City of St. Helens

Planning Commission

**CITY OF ST. HELENS PLANNING DEPARTMENT
STAFF REPORT**

EMERALD MEADOWS SUBDIVISION
PRELIMINARY PLAT
PLAN

PRELIMINARY
UTILITY PLAN

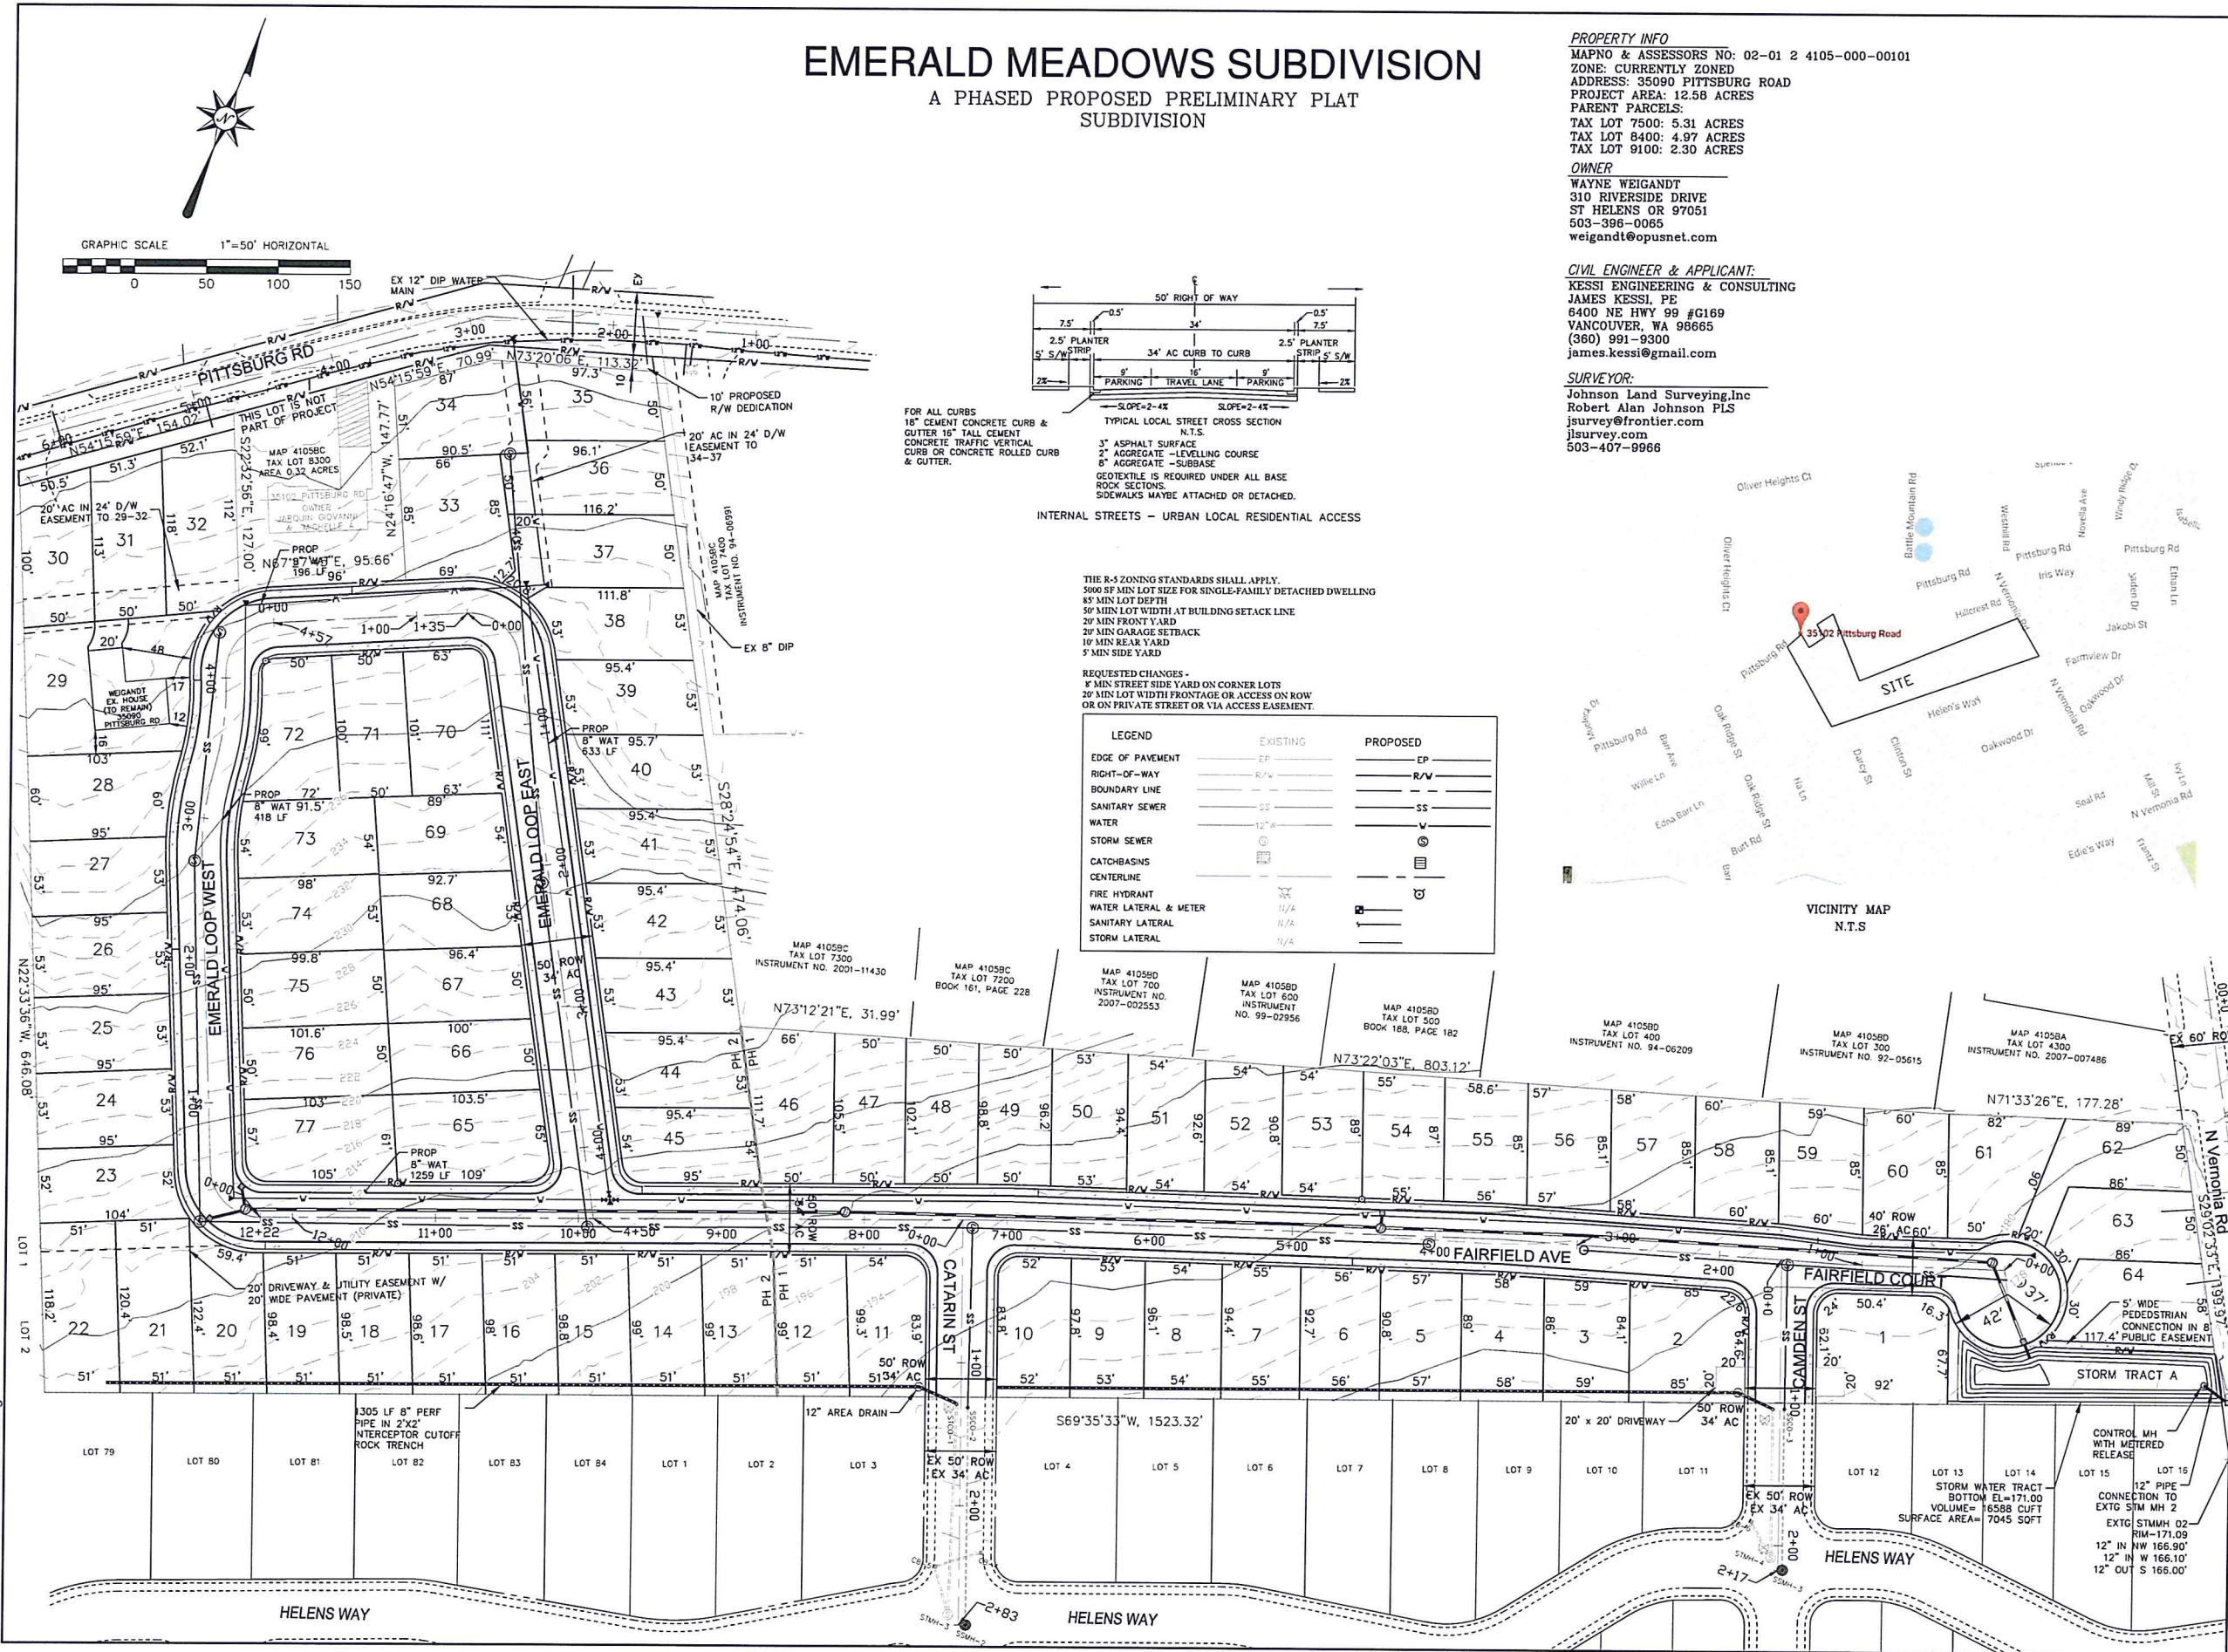
City Engineering: Engineering will require the sanitary sewer main near lots #33-#37 to be extended to the Pittsburg Road ROW. Some modifications will be required to the preliminary utility plan to bring the design into compliance with the City's design standards. Separate street

cross sections will be needed for the different street classifications of the proposed interior streets (local), Pittsburg Road (minor arterial), and N. Vernonia Road (collector). A drainage plan shall be submitted with or prior to the submission of the engineered drawings and shall include calculations for sizing the proposed detention facility, along with other required documentation and information. Additional private common backyard drainage will likely be required. Watermains shall be designed to provide the required operating pressure range of 50 to 90 psi at all times. New street lights shall use LED fixtures per the Columbia River PUD's design.

Properties along Hillcrest Road, between a leg of the subject property and Pittsburg Road (lying west of N. Vernonia Road), are not served by City Sanitary Sewer. They have sub-surface systems. Grading and other plans for this subdivision need to take that into account due to

potential health hazards (sewer leakage). Such plans need to include mitigation for nearby sub-surface system impacts as well as evaluate, if sub-surface failures occur, the optimum route for public sanitary sewer extensions to serve those properties to determine if easements for such connection are warranted on the subject property.

- iii. Sanitary sewer line shall be extended to the Pittsburg Road right-of-way, with appropriate easements per City standards.
 - iv. All applicable street cross sections representing the appropriate classifications per the City's Transportation Systems Plan.

- v. Watermains shall be designed to provide the required operating pressure range of 50 to 90 psi at all times.
 - vi. Fire hydrants shall meet the Fire District's hydrant standards. This includes a 5" stortz coupling and cap on the steamer port of the hydrant. Hydrants shall be spaced 400 feet per the Fire District for this subdivision. Hydrant locations shall include a blue reflective mark on the road identifying its location.

- vii. **For phase 2**, plans shall show how the public sanitary sewer line will be installed, tested, approved and accepted with the dwelling at 35090 Pittsburg Road connected prior to any impacts to the septic systems that would make the septic system inoperable.

- viii. **For phase 3**, plans shall show how the public sanitary sewer line will be installed, tested, approved and accepted with the dwelling at 35102 Pittsburg Road connected prior to any impacts to the septic systems that would make the septic system inoperable.

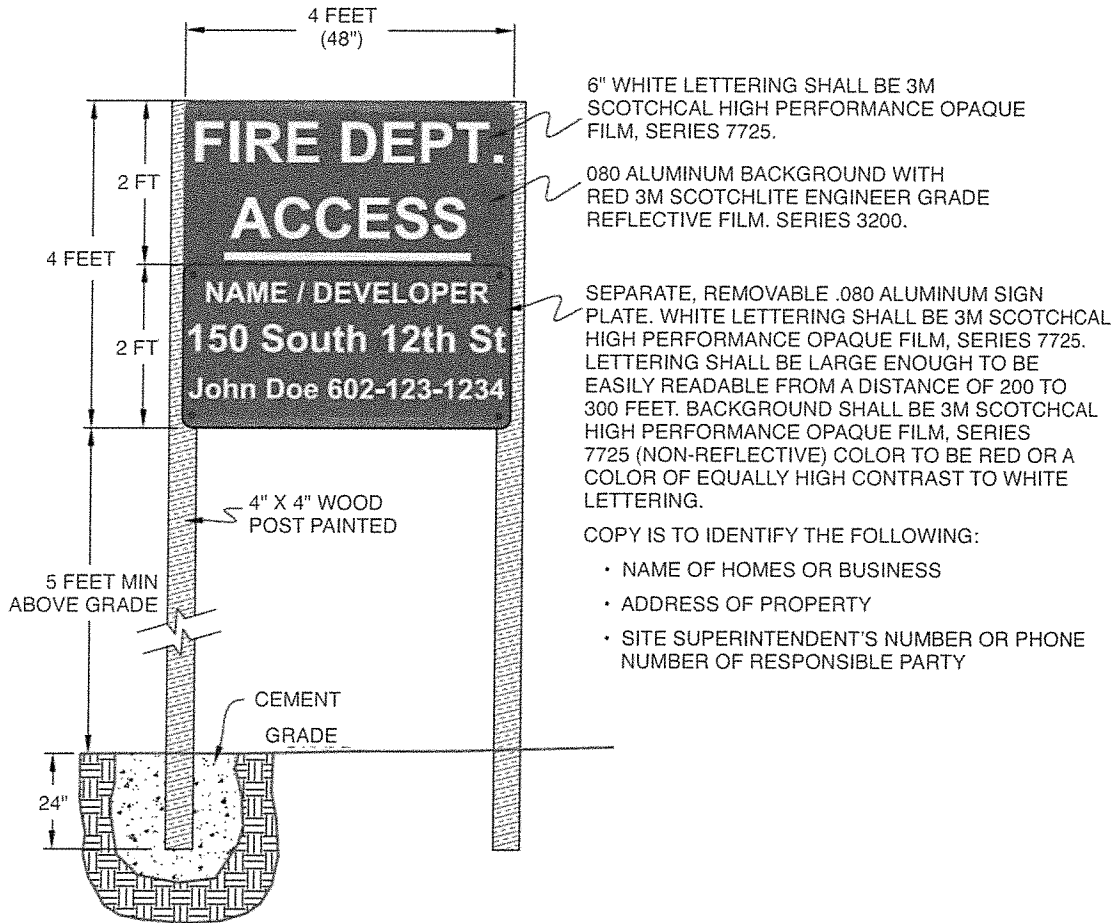
2. The fire district has the same comments for the access road for lots 29-32.
3. The Cul-De-Sac on Fairfield Court is too small. The current Fire Code is 96' The drawing shows 2 different radius. One at 37' the other at 42'. Both radius are short of the 96' requirement.

7. The fire district will be requiring the access roads used during the construction process to be identified and signed per the fire district standard.
